SUBJECT: WOLF CREEK GENERATING STATION - AMENDMENT NO. ¹³ TO FACILITY
OPERATING LICENSE NO. NPF-42 (TAC NO. 65903)

KANSAS GAS & ELECTRIC COMPANY
KANSAS CITY POWER AND LIGHT COMPANY
KANSAS ELECTRIC POWER COOPERATIVE, INC.
WOLF CREEK GENERATING STATION
DOCKET NO. 50-482
AMENDMENT TO FACILITY OPERATING LICENSE

ATTACHMENT TO LICENSE AMENDMENT NO. 13

SAFETY EVALUATION BY THE OFFICE OF NUCLEAR REACTOR REGULATION
SUPPORTING AMENDMENT NO. 13 TO FACILITY OPERATING LICENSE NO. NPF-42

FIGURE 6.2-2 UNIT ORGNIZATION

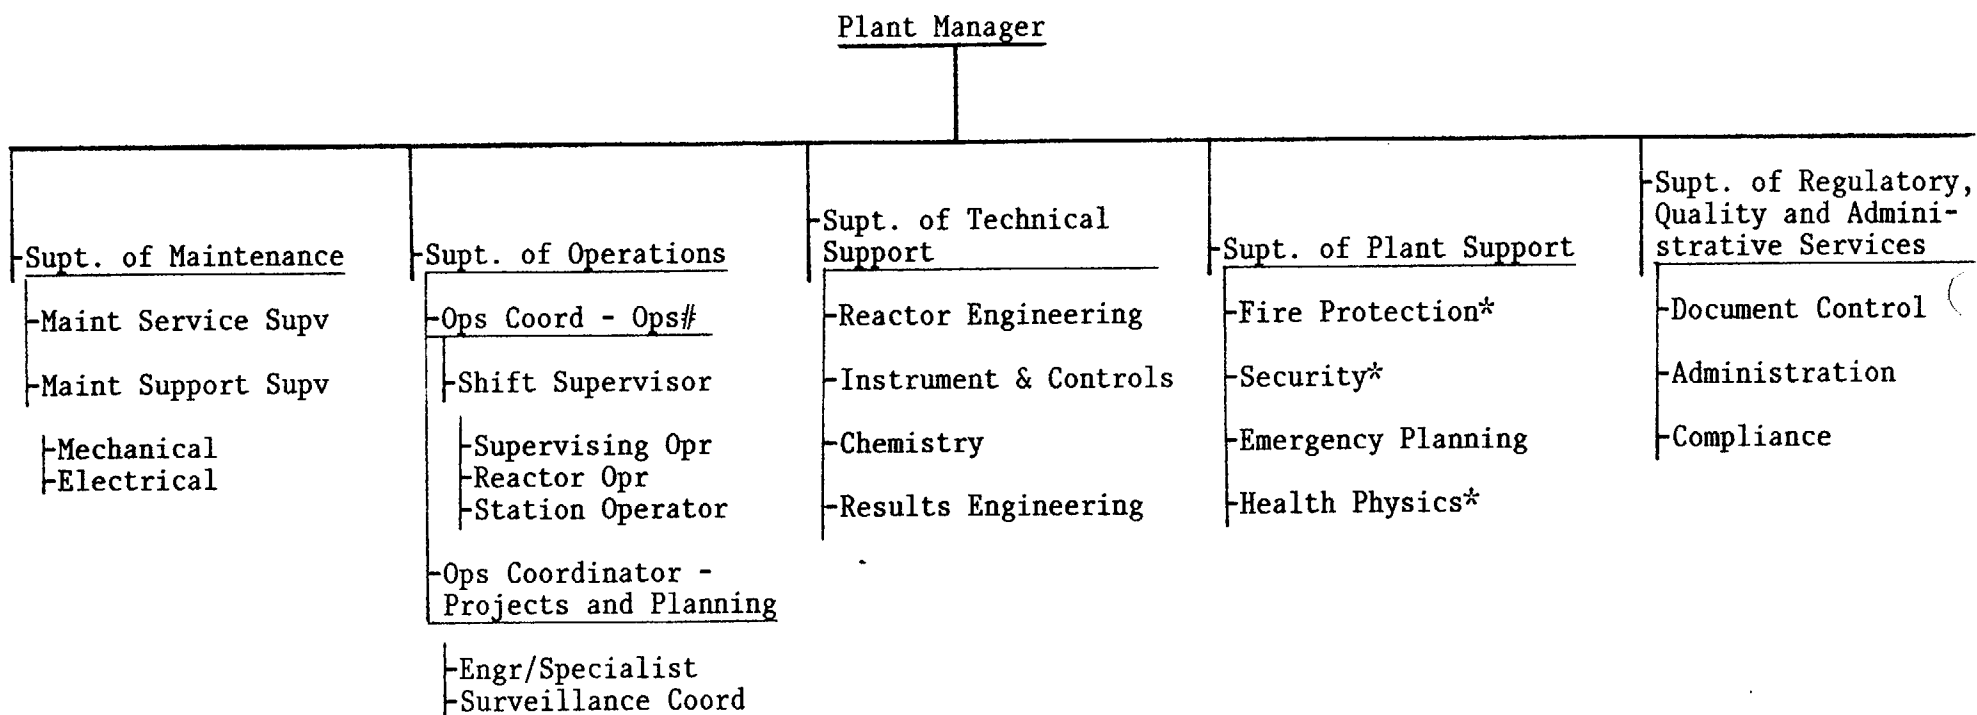
The amendment revises Technical Specification Figure 6.2-2 to reflect changes in organizational reporting relationships. Technical Specification 6.3.1 is also being revised to replace reference to the Site Health Physicist with a reference to the Radiation Protection Manager.

The first revision reflects changes in reporting relationships. The Medical and Safety Groups are being deleted from Figure 6.2-2 as they now report through the Operating Corporation Organization, Figure 6.2-1, to the Director Administrative Services. The Results Engineering Group previously reporting to the Superintendent of Plant Support now reports to the Superintendent of Technical Support. The Health Physics Group previously reporting to the Superintendent of Technical Support now reports to the Superintendent of Plant Support.

1. Figure 6.2-2, Unit Organization

The licensee has revised the unit organization, Figure 6.2-2, by transferring the Health Physics functional unit from the Superintendent Technical Support to the Superintendent of Plant Support, the Results Engineering functional unit from the Superintendent of Plant Support to the Superintendent of Technical Support, and deleting the Medical and Safety Groups from Figure 6.2-2 as they now report through the Operating Corporation Organization, Figure 6.2-1.

We find these requested changes acceptable as they do not delete any of the technical support necessary for the operation of the Wolf Creek Generating Station Unit No. 1, and they meet the acceptance criteria of Section 13.1.2-13.1.3 of NUREG-0800, the Standard Review Plan.
